SUBJECT: Forwards addl info re inservice insp weld program, in response to NRC 820405 ltr.

Donald C. Cook Nuclear Plant Units No. 1 and 2  
Docket Nos. 50-315 and 50-316  
License Nos. DPR-58 and DPR-74  
INSERVICE INSPECTION PROGRAM

ADDITIONAL INFORMATION ON INSERVICE INSPECTION PROGRAM

ATTACHMENT TO AEP:NRC:00070F

Sketch A

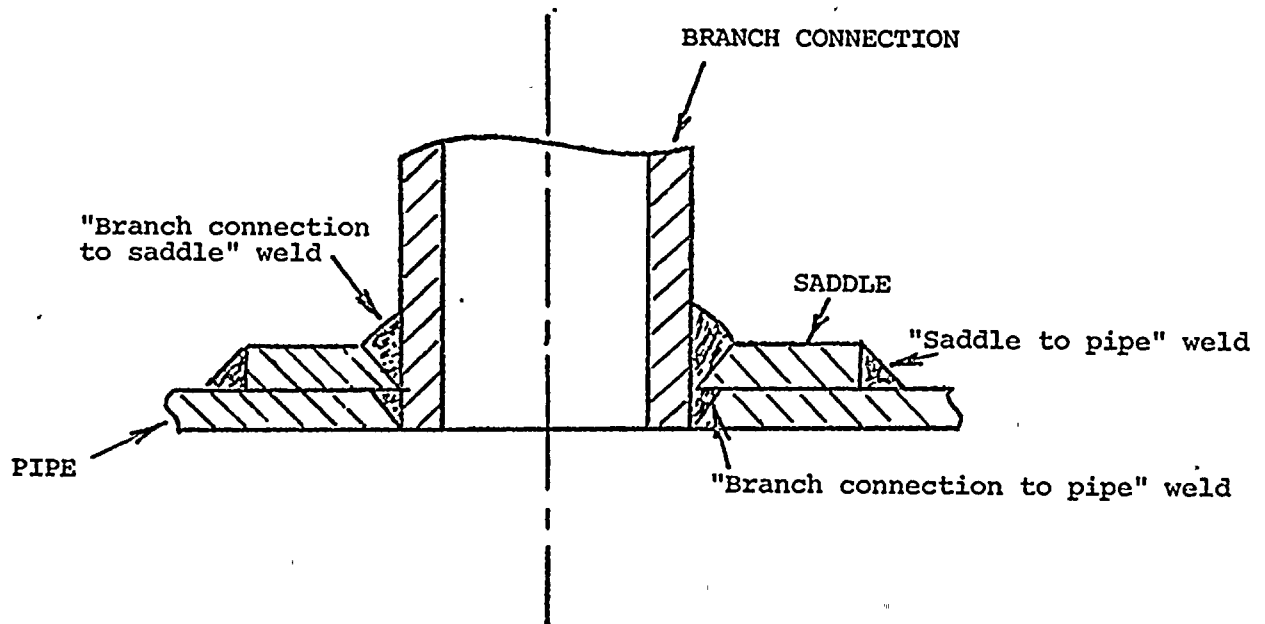
- (d) Table 1 identifies a number of welds as "saddle to pipe" welds whose inspection was augmented because the welds were not structural. These welds are all of a particular type which is one of the three welds shown on Sketch A of this Attachment. A re-evaluation of these welds indicates that they are pressure retaining welds and should be category C-G requiring volumetric examination. However, volumetric examination is impractical because the fillet weld configuration does not lend itself to UT or RT. Surface examination is the alternate method proposed. These fillet welds have been included in the Long Term Plan for surface examination. Scheduled examinations have been performed. These welds will be transferred from Table 1 to Table 2, and will be identified for Code relief as EX-2A. ("EX-2A- Configuration does not permit volumetric examination. Alternate is surface examination".) These welds are listed in Table U of this attachment.

- i) "Branch connection to saddle" welds are listed in Table 2 and identified under "Category" as C-G and under "Remarks" as "No scan due to configuration", and listed for exempt code EX-2. These welds are all of a particular type which is also shown in Sketch A and listed in Table V.

Category C-G requires volumetric examination which is impractical for this weld configuration. Surface examination is the alternate method proposed. These welds are included in the Long Term Plan for surface examination and scheduled examinations have been performed. These welds will be re-classified as EX-2A in Table 2 when it is revised.

- ii) "Branch connection to pipe" welds are covered by a saddle that restricts access. These welds were identified in Table 2; "Remarks" column, as "P-N weld under saddle", and

listed for generic exempt code EX-3. No alternate examination is proposed. These welds are also all of a particular type as shown in Sketch A and listed in Table W.

"Branch connections to saddle welds" are shown on Sketch A. This is a unique weld configuration and was discussed in 2(b)(i).

Sketch B

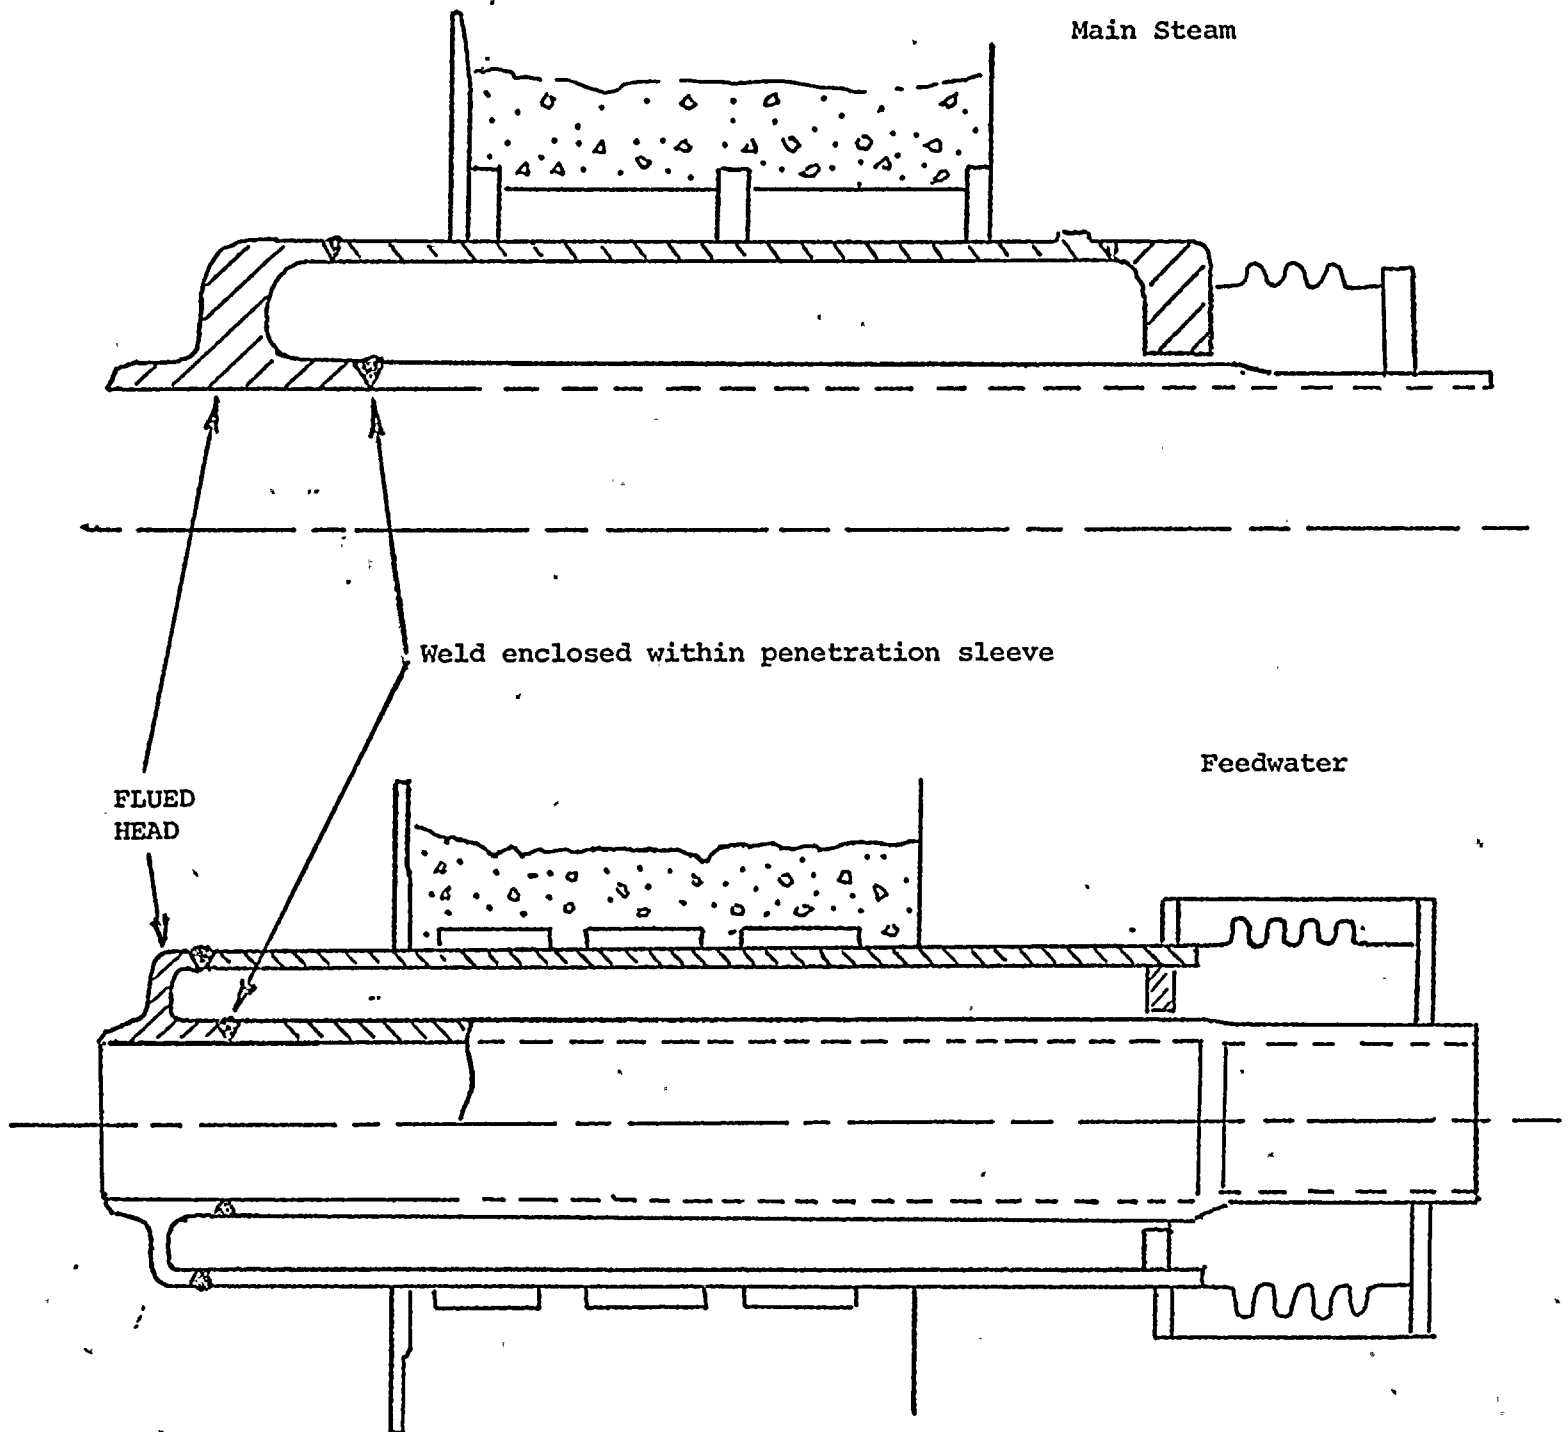
- iv) Containment penetration flued head to pipe welds are restricted from access since they are totally enclosed within a sleeve. These welds were identified in Table 2, "Remarks" column, as "within sleeve on penetration", and listed for exempt code EX-3. No alternate examination is proposed. These welds are shown in Sketch B and identified in Table Y.

- (c) EX-3. This exception was used for "branch connection to pipe" welds that are covered by a saddle (Sketch A), and welds within containment penetrations (Sketch B). In all cases it is physically impossible to gain access to the weld to perform nondestructive examination. In no case was "height" or the personnel safety the reason for using this exception.

SKETCH C

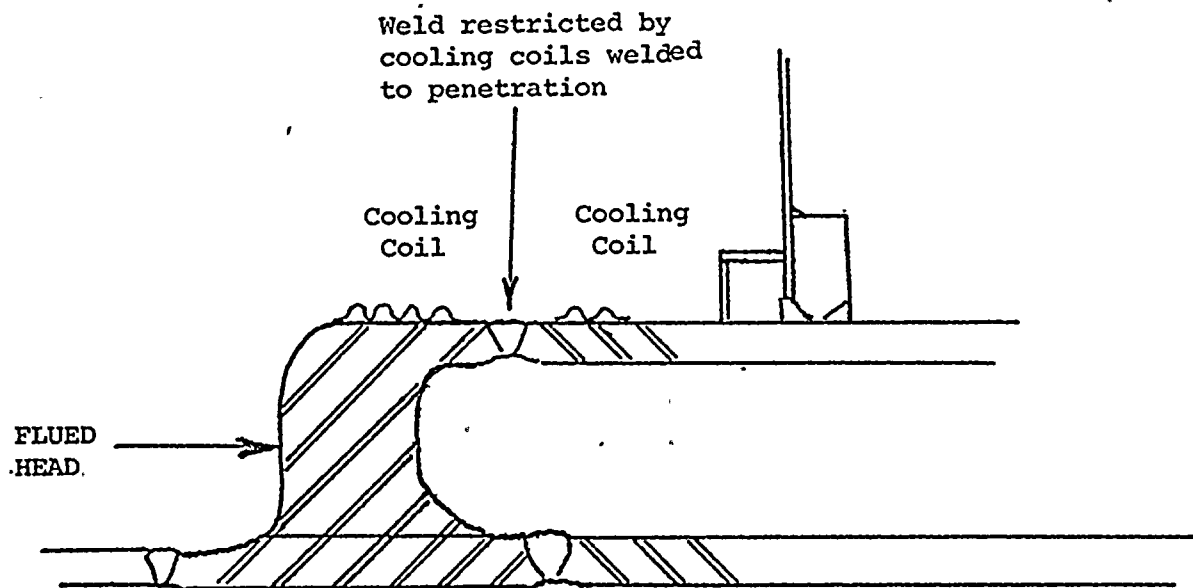
- v) Containment penetration flued head to embedment sleeve welds have restricted access due to cooling coils welded on either side of the head to sleeve weld. These welds are identified for Unit 1 in Table 2, "Remarks" column, as "axial clearance restricted by cooling coil", and listed for exempt code EX-2. For Unit 2, these welds were listed in Table 1 as C-G without any remarks. These welds are shown in Sketch C and identified in Table Z. A re-evaluation of these welds indicates that they are pipe support welds and should be category C-E-1 requiring a surface examination. These welds will be listed in Table 1 as C-E-1. No code relief is required.

Penetration welds with restricted access due to cooling coils are shown on Sketch C. They are discussed in 2(b)(v), and exception is no longer required.
